**Application by Highways England for M54 to M6 Link Road
Response to the Applicants 8.20 Review of Woodland Mapping, Impact Assessment and
Compensation – Revised Design - Issued on 12 Jan 2021**

**Response Deadline 5 20th Jan 2021
Responses From: Allow Ltd**

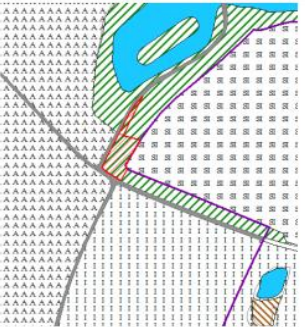
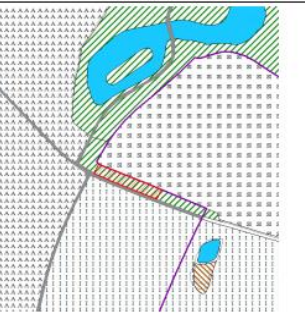
4. Appendix A of TN8.20 shows there has been an inaccurate application of buffers to several areas, including woodland being clear felled, land comprising tarmacked pavements, open grassland and land comprising other non-woodland habitats, examples of which are evidenced at Appendix 1 of this document. This is not in accordance with the aforementioned methodology for the buffer mitigating potential losses along edges of remaining woodland. The inclusion of other non-woodland habitats is not mentioned in the body of TN8.20, but only in the Appendix table.
